**ZONING AMENDMENT,  
PLANNING APPROVAL &  
SUBDIVISION STAFF REPORT**

**Date: April 21, 2016**

<b><u>NAME</u></b>	Mobile Gas Corporation
<b><u>SUBDIVISION NAME</u></b>	Mobile Gas - Downtown Park Subdivision
<b><u>LOCATION</u></b>	804 Dr. Martin Luther King Jr. Avenue (Northeast corner of Dr. Martin Luther King Jr. Avenue and Marmotte Street extending to the Southeast corner of Marmotte Street and Short Bloodgood Street)
<b><u>CITY COUNCIL DISTRICT</u></b>	District 2
<b><u>PRESENT ZONING</u></b>	R-3, Multiple-Family District, and B-4, General Business District
<b><u>PROPOSED ZONING</u></b>	R-2, Two-Family Residential District
<b><u>REASON FOR REZONING</u></b>	To eliminate split zoning.
<b><u>AREA OF PROPERTY</u></b>	1 Lot / 7.4 ± Acres
<b><u>CONTEMPLATED USE</u></b>	Subdivision approval to create 1 lot, Planning Approval to allow a park in an R-2, Two-Family Residential District, and Rezoning from R-3, Multiple-Family District, and B-4, General Business District, to R-2, Two-Family Residential District, to allow a park and eliminate split zoning. <b>It should be noted, however, that any use permitted in the proposed district would be allowed at this location if the zoning is chan

# DETAIL SITE PLAN

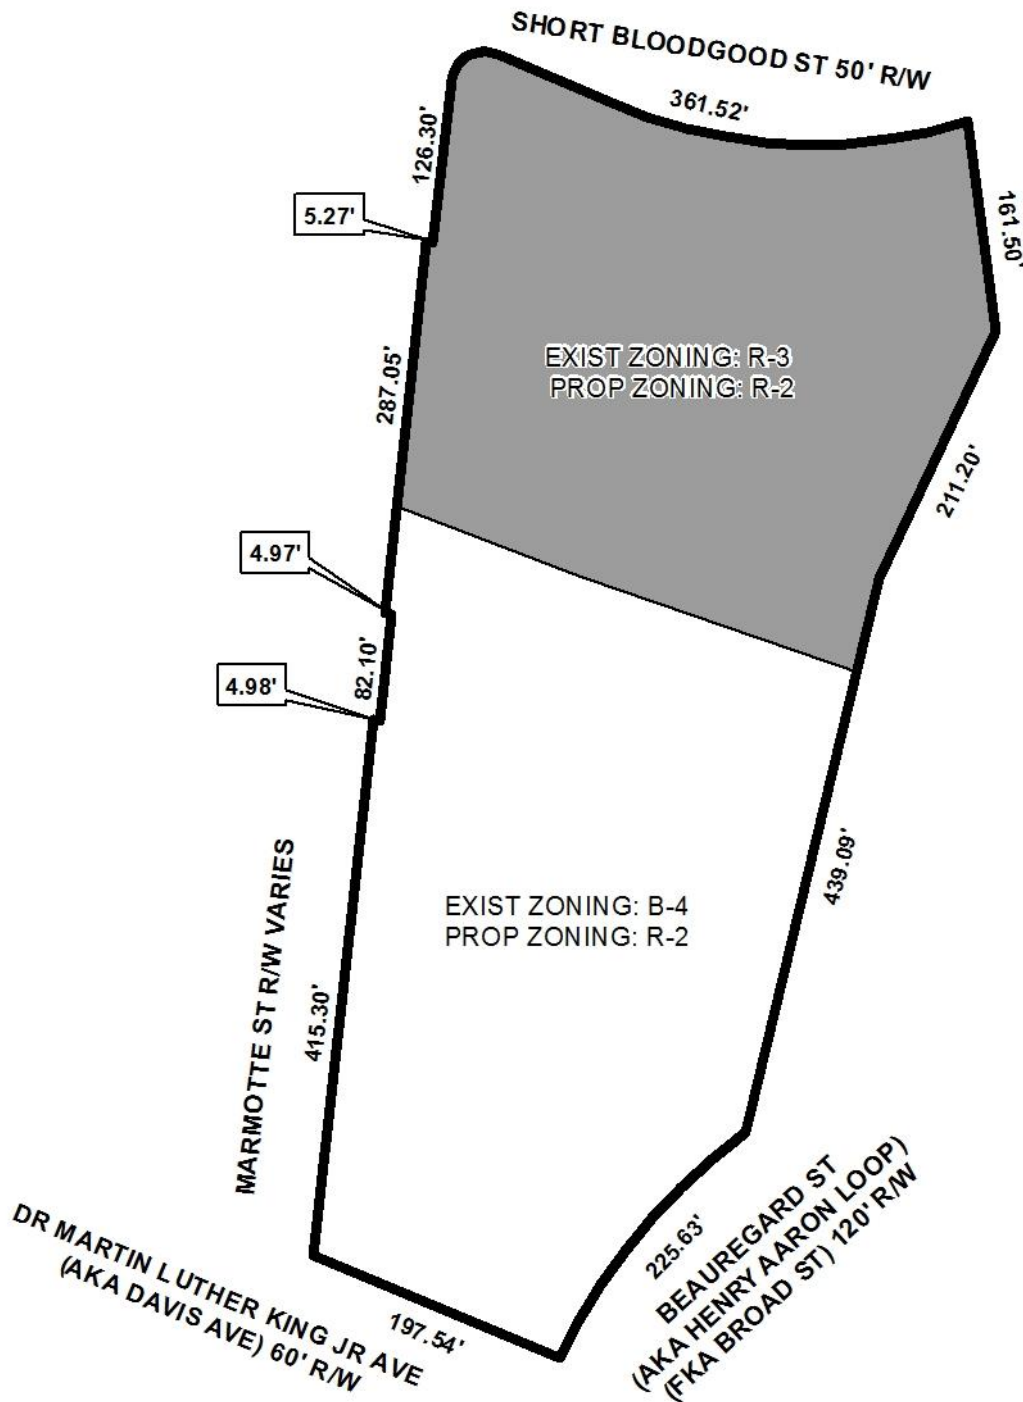
Regarding the proposed use of the site as a park, a sidewalk with benches through the site are proposed at this time. The sidewalk will connect to the abutting streets at several points, however, continuous new sidewalks along the streets do not appear to be proposed beyond what currently exists. The proposed sidewalks that will parallel Marmotte and Short Bloodgood Streets will be approximately 25-feet from the right-of-way edge, and thus may be close enough and easily accessible enough to provide pedestrian connectivity that might otherwise be provided by a sidewalk along the edge of the right-of-way. There is no indication that there will be any structures, such as a pavilion or restroom facility.

Most of the existing trees on the site will be retained, however, it appears that five trees will be removed during the remediation and site modification process: one of the trees to be removed is a live oak greater than 24 inches, thus a tree removal permit will be required.

There are multiple existing curb-cuts to the site, including one onto Beauregard Street, a major street, three onto Marmotte Street, and one onto Short Bloodgood Street. The site plan submitted with the application does not indicate that there will be on-site vehicular parking, thus the curb-cut onto Beauregard Street and two of the curb-cuts onto Marmotte Street should be removed, and the curbing and neutral ground restored.

Finally, it should be noted that there is a water line easement crossing the property. All easements on the property should be labeled. A note should be placed on the Final Plat stating that no structures shall be placed in any easement.

- 1) Revision of the site plan to reflect curb-cut removals and minimum building setback line adjustments along Marmotte Street;
- 2) Revision of the 25-foot minimum building setback line along Marmotte Street to reflect a future continuous right-of-way width of 50-feet;

- 3) Removal of one existing curb-cut to Beauregard Street and two existing curb-cuts to Marmotte Street, and the restoration of curb-and-gutter and the neutral ground;

- 5) Labelling of all easements, and placement of a note on the site plan stating that no structures shall be placed in any easements;

- 6) Removal of any 24 inch or larger Live Oak on the property to be appropriately permitted through Urban Forestry;
- 7) Compliance with Traffic Engineering comments (*Driveway number, size, location and design to be approved by Traffic Engineering and conform to AASHTO standards. Required on-site parking, including ADA handicap spaces, shall meet the minimum standards as defined in Section 64-6 of the City's Zoning Ordinance.*);
